21 March 2023

Northern Beaches Council
c/o Kye Miles, Planner

DEVELOPMENT APPLICATION DA2022/2270 AT 166 PITTWATER ROAD MANLY NSW 2095

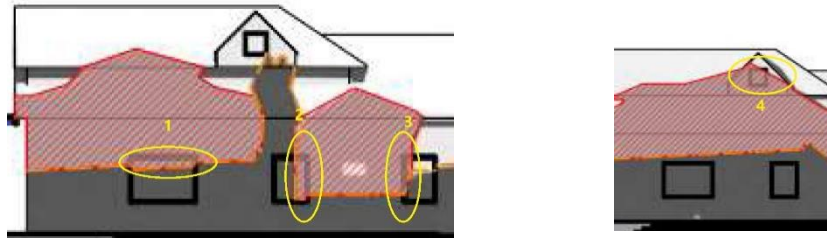
5. According to the Manly Development Control Plan 2013 ('the DCP'), in relation to sunlight to the windows or glazed doors to living rooms of adjacent properties, for adjacent buildings with an east-west orientation, the level of solar access presently enjoyed must be maintained to windows or glazed doors to living rooms for a period of at least 2 hours from 9am to 3pm on the winter solstice, and for all adjacent buildings (with either orientation) no reduction in solar access is permitted to any window where existing windows enjoy less than the minimum number of sunlight hours specified above.¹
6. A perusal of the shadow diagrams provided by Tony Robb,² gives rise to a concern that the that the DA will contravene the rules stipulated by the DCP.

7. These two shadow diagrams are used to simulate the solar access between noon and 3:00 pm in mid-winter.³ The concern is that the solar access of the adjoining property, as marked on the diagrams above, could be significantly compromised. Further, such a design is potentially at odds with the DCP which seeks to promote equitable access to light and sunshine.⁴
8. Although the Report contends that the proposed development will not create any significant additional overshadowing to windows to the property,⁵ it is submitted that overshadowing of even a minor kind is not something that the Council should allow. In *Archiworks Architects Pty Ltd v Marrickville Council* [2005] NSWLEC 164 (**Archiworks**), the Land and Environment Court found:

9. It is the writer's position that any DA should ensure that it maintains reasonable amenity for the dwelling on the adjacent property. Simply because it is suggested that there has been some shading of the windows in question, does not convert to the proposition that further overshadowing should be seen as acceptable. To the contrary, it is submitted that the applicant has an obligation to maintain and promote reasonable amenity for the limited sunlight available.

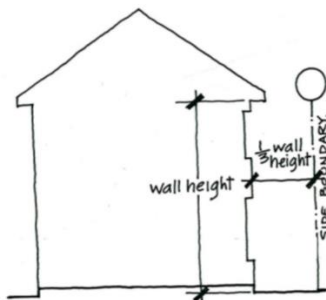
10. The development proposal intends to provide for roughly 6.59 m high wall on the common wall, thereby affecting our semi-detached house.⁷ The immediate concerns associated with the erection of this structure is interference with amenity, as well as safety considerations.

11. The protection of reasonable amenity is one of the paramount considerations set out by the DCP.⁸ In *Archiworks*, the development plan proposed to build a 5 to 6 m high brick wall on the boundary with the adjoining semi-detached house. However, the Court found:

12. It is noteworthy that the common wall in the middle of the semi-detached house is not one that was built in recent decades. Absent further information being provided, it is simply not known whether the common wall can withstand a development of this magnitude. According to rule 3.10 of the DCP, the safety of any development is a critical issue that needs to be considered carefully.¹⁰ In these circumstances, it is submitted that further expert opinion as to weighting and safety considerations should be obtained from a structural engineer.
